## PIC16F88X Family Silicon Errata and Data Sheet Clarification

The PIC16F88X family devices that you have received conform functionally to the current Device Data Sheet (DS41291G), except for the anomalies described in this document.

The following typographic corrections and clarifications are to be noted for the latest version of the device data sheet (DS41291G):

**FIGURE 1: SCK PULSE VARIATION USING TIMER2/2**

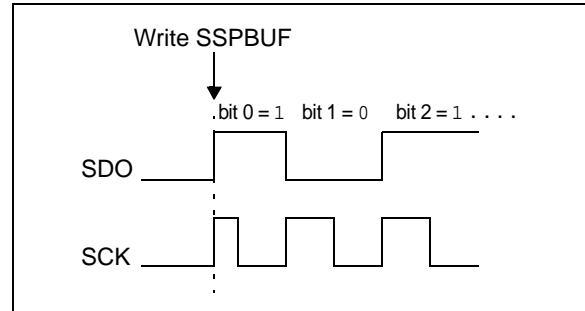
When the SPI is using Timer2/2 as the clock source, a shorter than expected SCK pulse may occur on the first bit of the transmitted/received data (Figure 1).

To avoid producing the short pulse, turn off Timer2 and clear the TMR2 register, load SSPBUF with the data to transmit and then turn Timer2 back on. Refer to Example 1 for sample code.

**FIGURE 3: ACTUAL (INCORRECT) OPERATION WITH CLOCK STRETCHING – EXAMPLE 1**

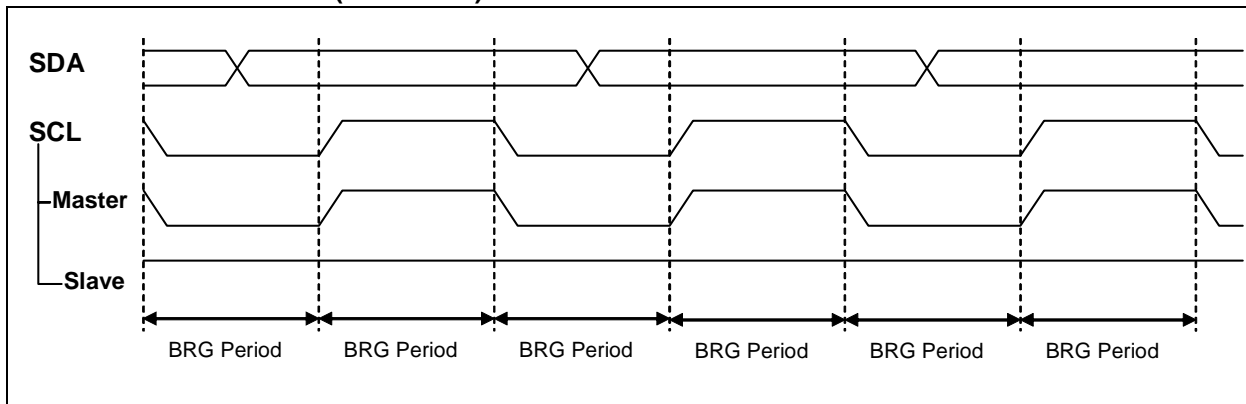
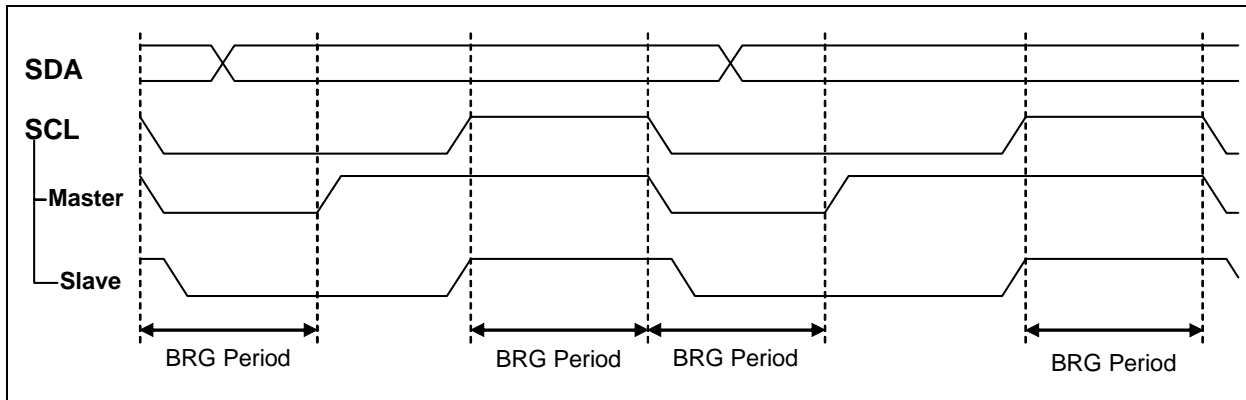
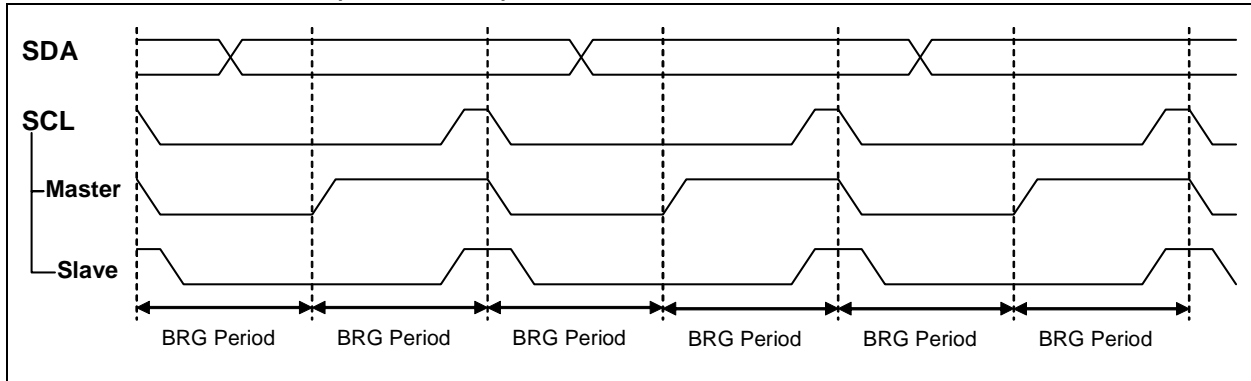
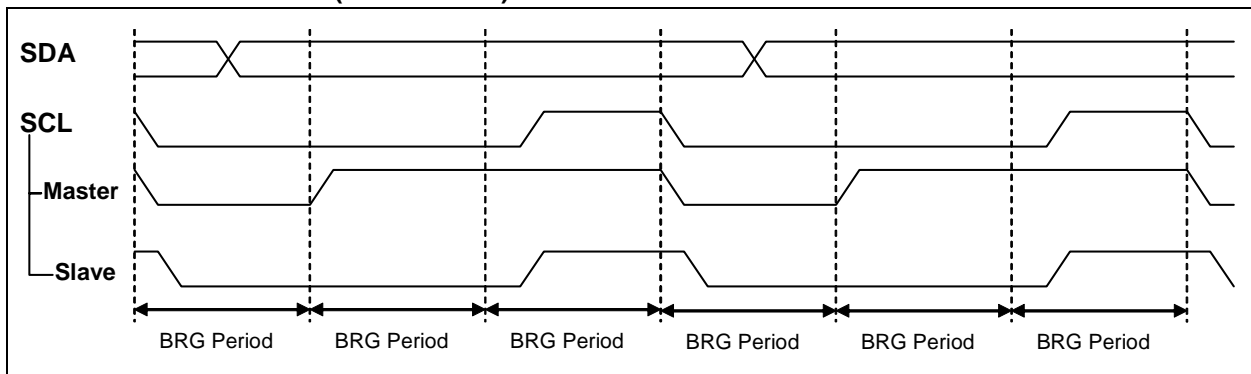
When the MSSP is I<sup>2</sup>C™ Master mode with a slave device stretching the clock, the clock generation does not function as described in the data sheet.

When a slave device is performing clock stretching by pulling the SCL line low, the master device should continuously sample the SCL line to determine when all slaves have released SCL. When SCL is released, the master device should wait one BRG period to ensure a constant SCL high time.

The current implementation does not ensure accurate SCL high time. During clock stretch, the MSSP device will erroneously continue running the BRG counter. At the end of the clock stretch, the BRG counter continues to count down for the

remainder of the BRG period, and then the MSSP device will immediately resume transmitting the data.

Figure 1 illustrates an expected I<sup>2</sup>C transmission in which the SCL line is completely controlled by the master device and the slave device does not attempt to stretch the clock period.

Figure 2 illustrates the expected operation of an I<sup>2</sup>C transmission in which the slave device has stretched the clock period by holding the SCL line low. The high time of the SCL pulse is constant, regardless of the duration of the clock stretch.

Figure 3 and Figure 4 illustrate an actual I<sup>2</sup>C transmission in which the slave has stretched the clock period by holding the SCL line low. Note that the high time of the SCL signal has shortened from the expected time.

Set the communication speed to match the slowest device on the bus. This ensures that no slave device will perform clock stretching.

It is possible to dynamically adjust the communication speed to match the device being addressed by modifying the BRG register. However, the behavior of slower slave devices must be understood and speed adjustments made such that no slave performs clock stretching.
